**UPPER UWCHLAN TOWNSHIP
PLANNING COMMISSION
AGENDA
January 13, 2022
7:00 p.m.**

Reference: Greenridge Road Conditional Use Plan (Toll)
Conditional Use Plan Review (3rd Review)
Upper Uwchlan Township, Chester County, PA

CONDITIONAL USE SUBDIVISION PLAN FOR GREENRIDGE ROAD

ROAD PLAN
ROAD 'A' STA. 1+00 TO STA. 27+00

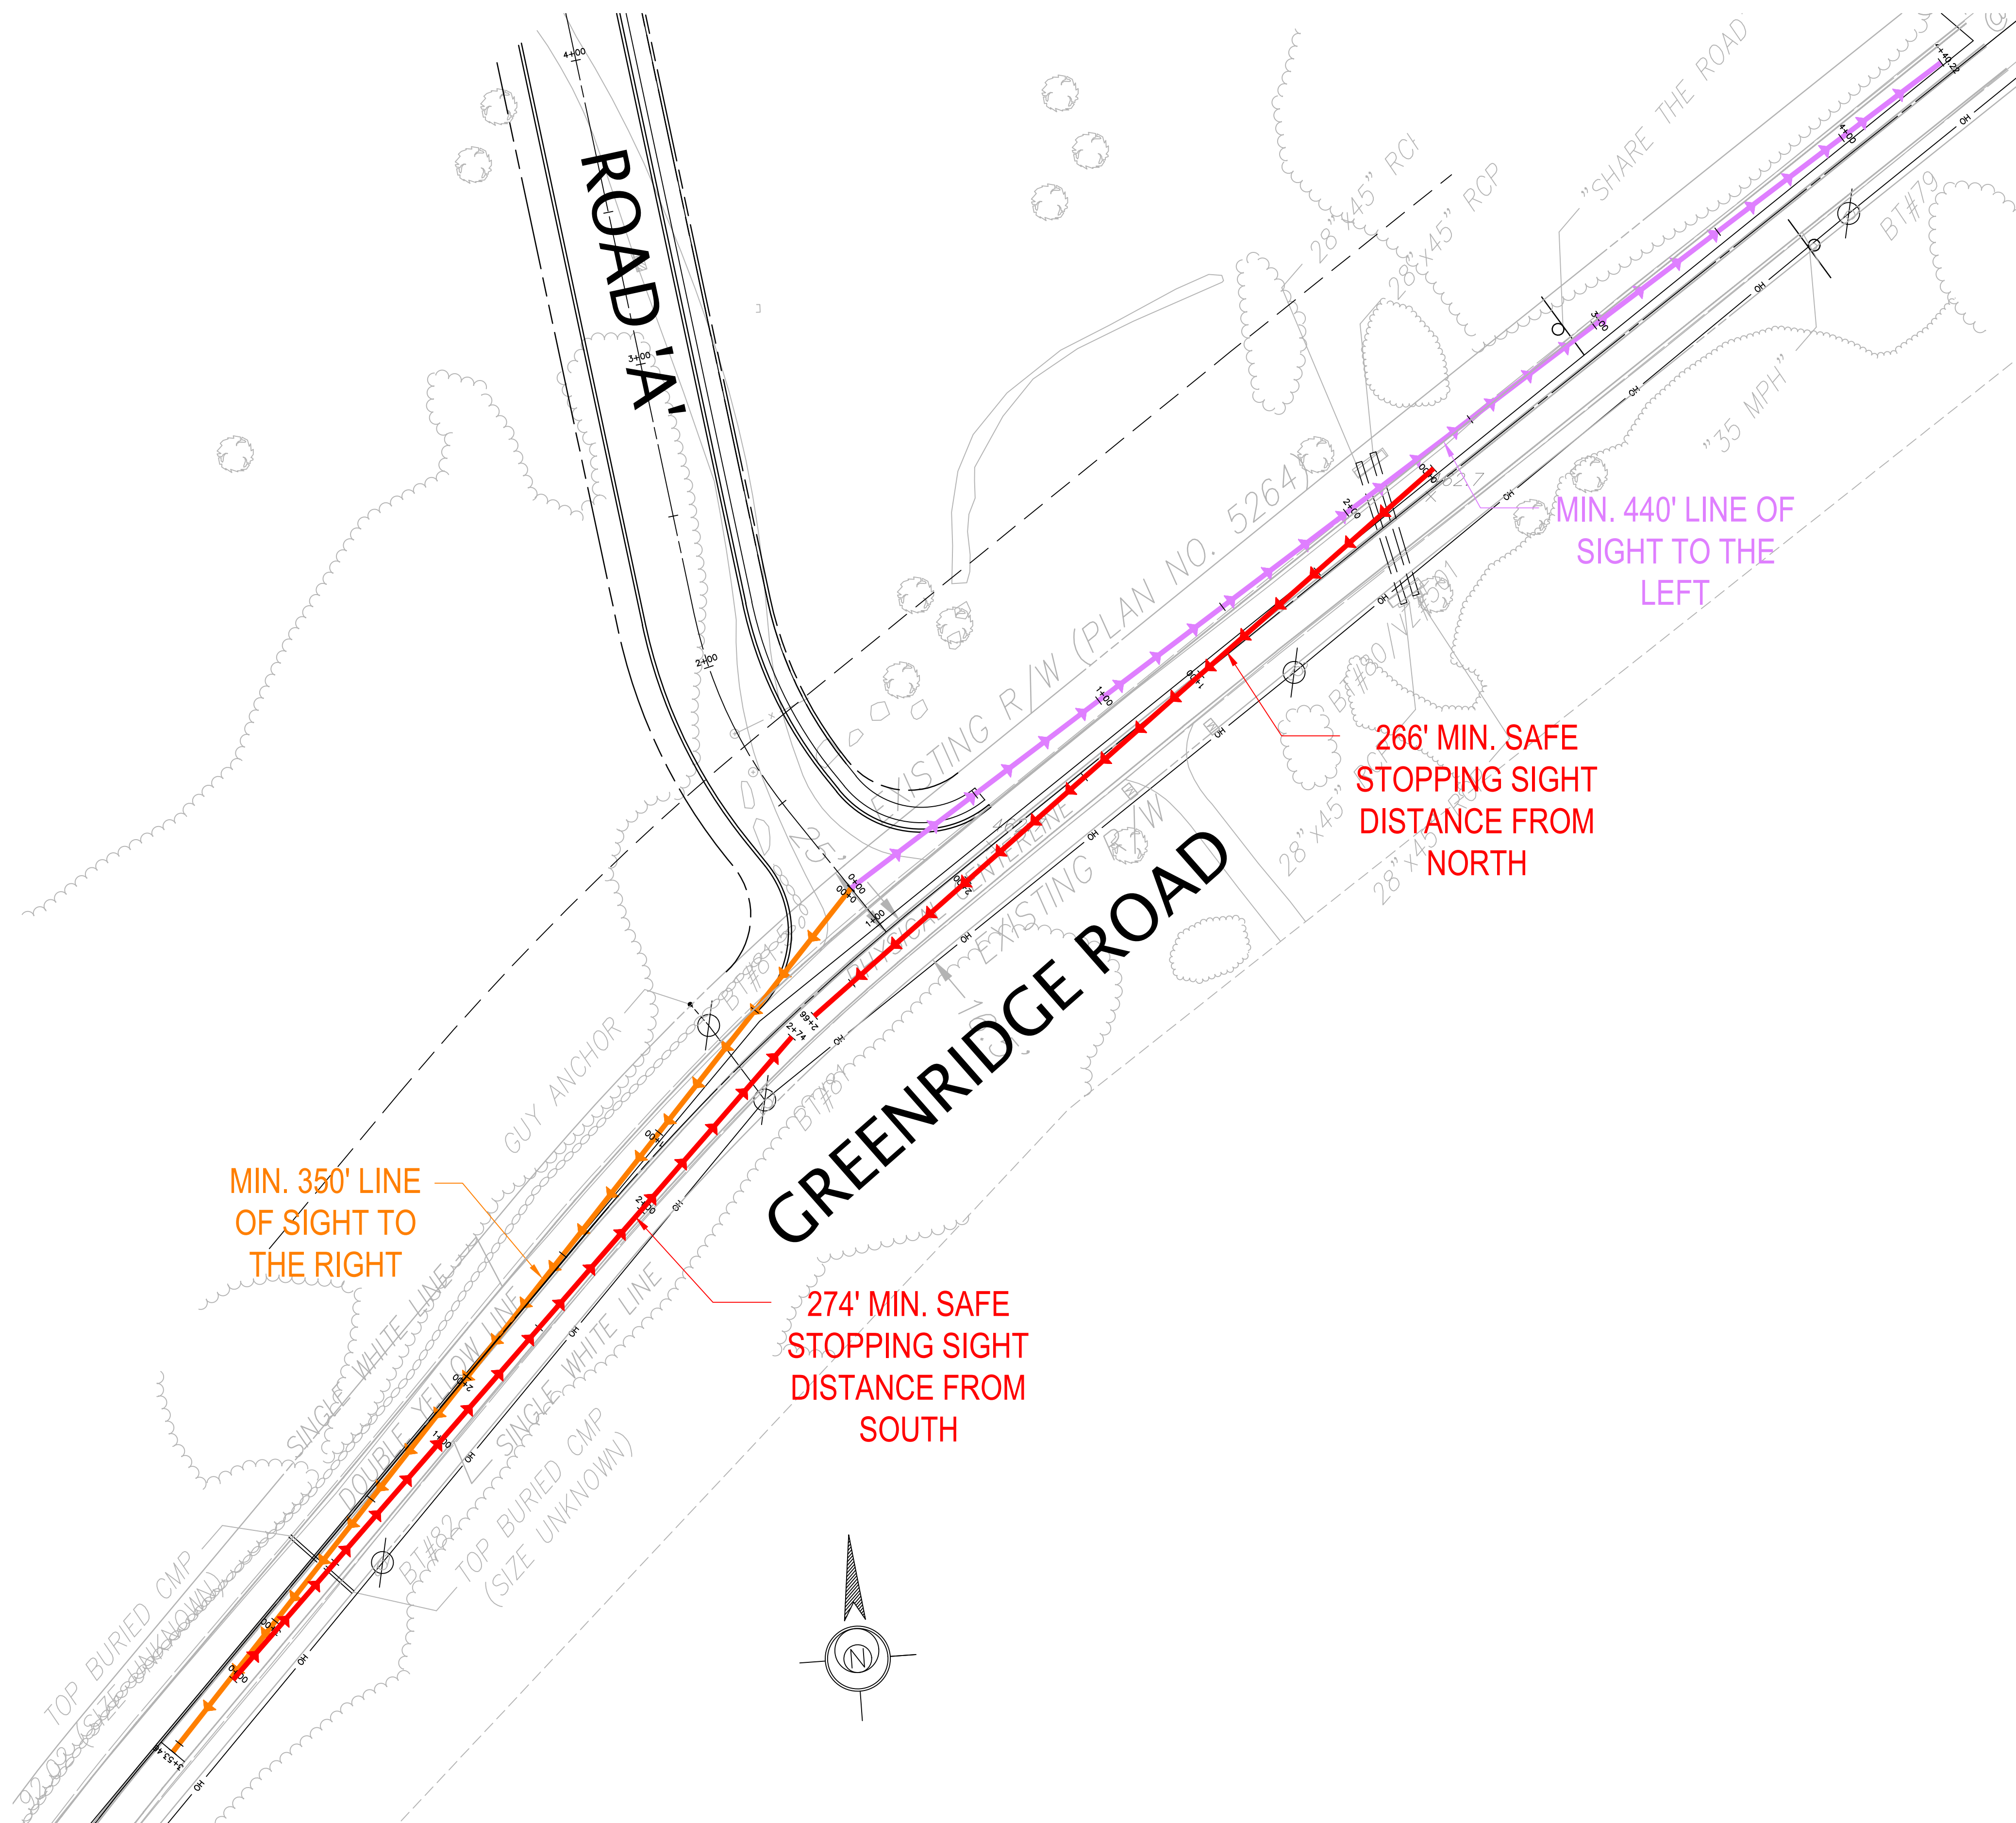
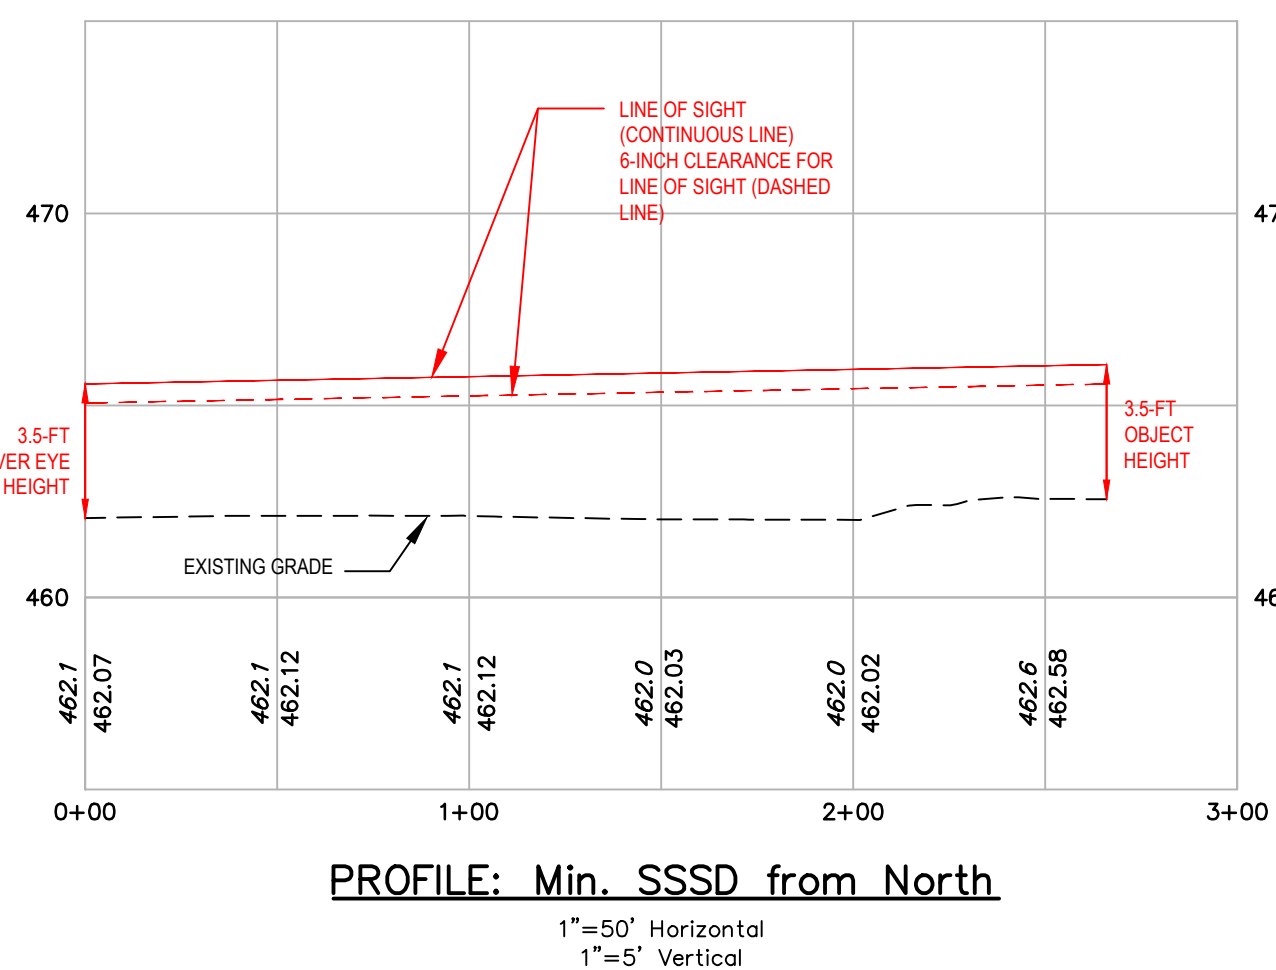
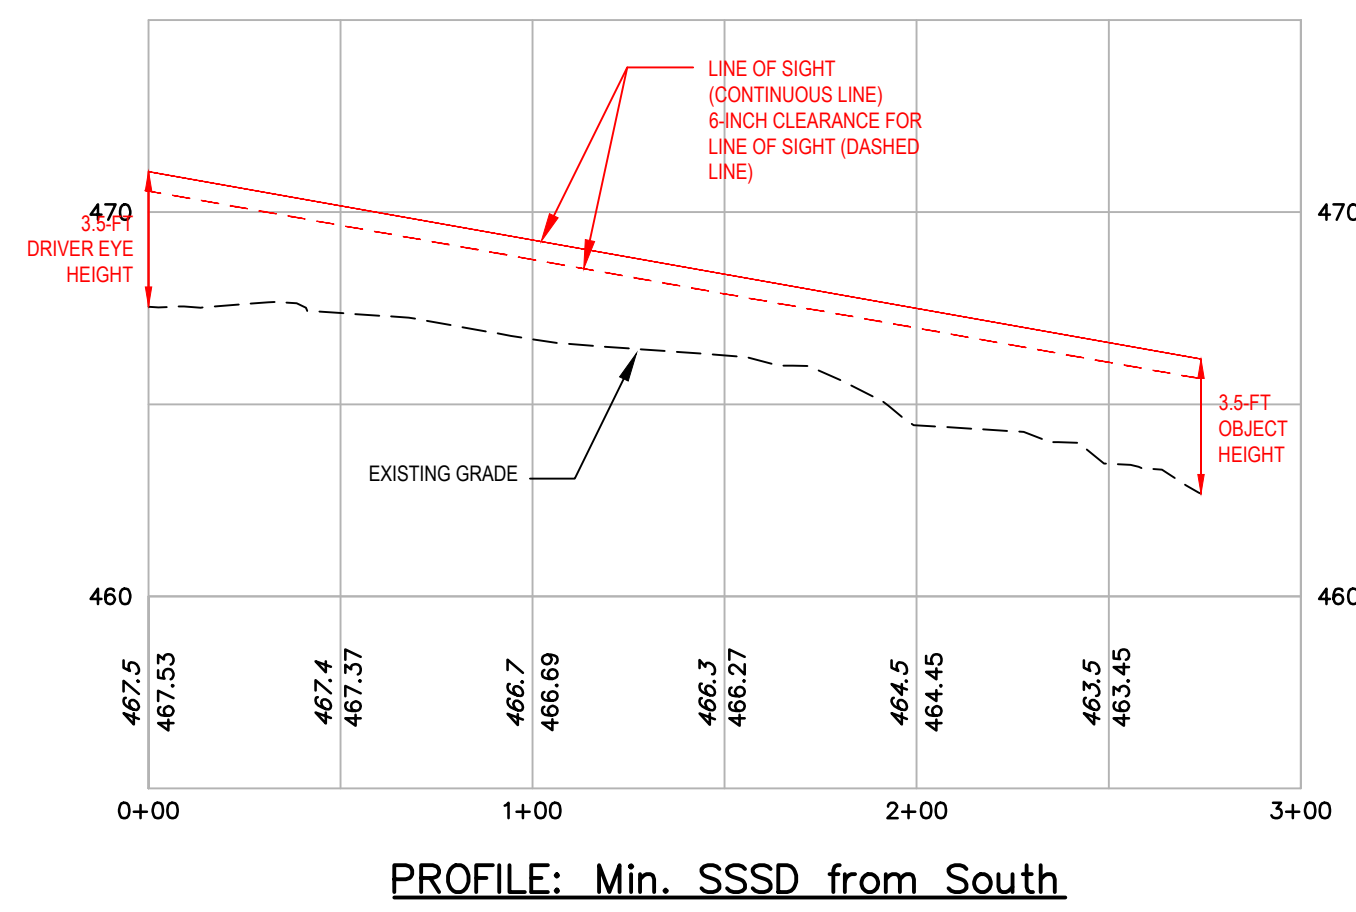
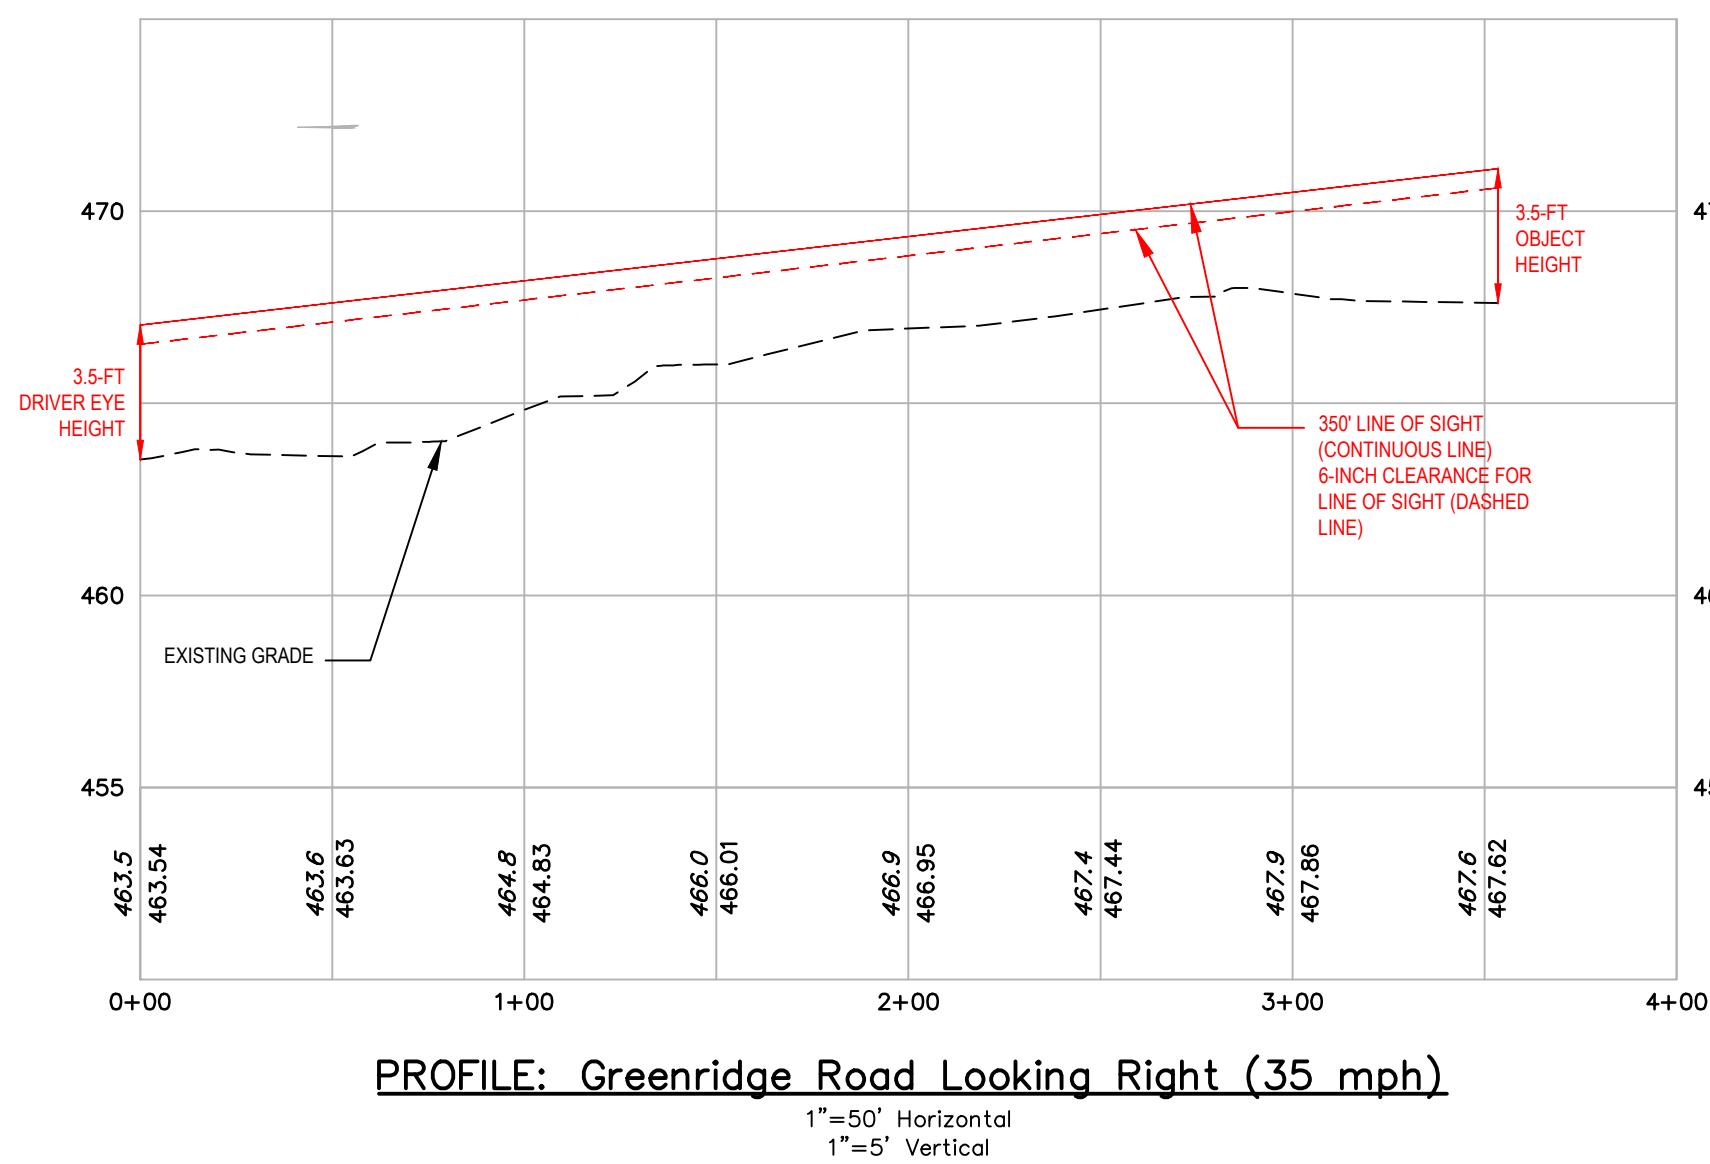
1. **(W)** Section 162-30.A – *Maximum grade for a local access road is 10%. The applicant is requesting a waiver to permit a maximum grade of 12%. If this waiver is to be considered as part of the conditional use process, a plan and profile of the roadway should be provided so an evaluation can be made. Otherwise, we would recommend this waiver request be defer until the land development submission.*

2. SALDO Sections 162-30.A – The applicant requests a waiver to allow an 11 percent grade along a section of Road A between Lots 4 and 64, which exceeds the required maximum grade along local streets of 10 percent. Based on the vertical profiles provided, it appears possible to revise the design to provide a maximum 10 percent grade (between STA 8+87.5 and STA 15+25) by increasing the 6.08% grade (between STA 17+50 and STA 24+65) to seven percent, which would no longer require the requested waiver. As such, at this time, we do not support the waiver to allow the 11 percent grade. We recommend any decision on this waiver request should be deferred to land development when more detailed engineering information is available.

As requested, the Applicant has provided a plan and profile indicating the proposed vertical alignment for the roadway. Based on our review of the submitted profile, it appears there may be an opportunity to reduce the slope of the section currently proposed to be constructed at 11% to 10% and increase the section of road currently proposed to be 6.08% to approximately 7% which would eliminate the need for this waiver. While we have no objection to the granting of this waiver to allow the roadway to be constructed as currently designed, we believe our above suggested configuration should be considered first.
